**Case 22444 - Site Plan
Approval: 1591 Granville/
1568 Hollis Street**

Design Review Committee

November 14, 2019

Proposal: 21-storey mixed-
use development with two
tower components

Public Benefit/ Wind Study

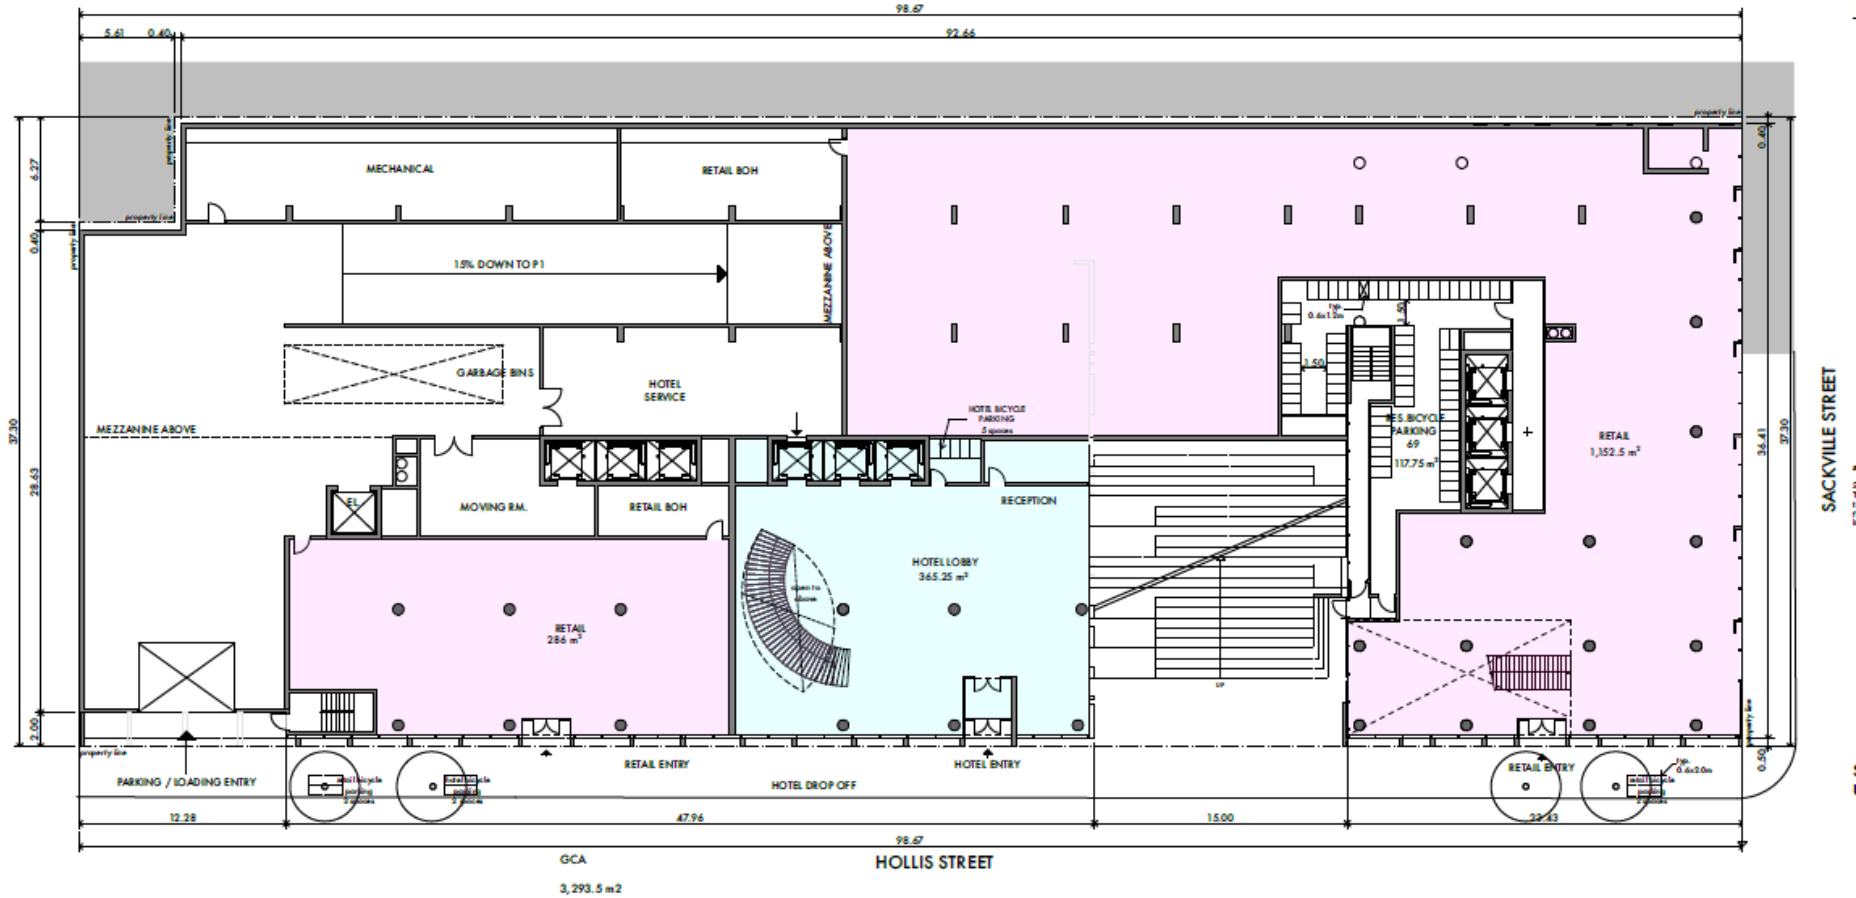
- Wind impact assessment:
 - wind conditions are expected to meet or surpass standards and meet the comfort and safety criterion;
 - higher glass guardrails were incorporated on north tower rooftop to address issues;
- Public benefit category:
 - Staff recommend *undergrounding of overhead electrical and communication distribution systems* *(only required if DRC decides to approve the proposed qualitative elements and variance requests)
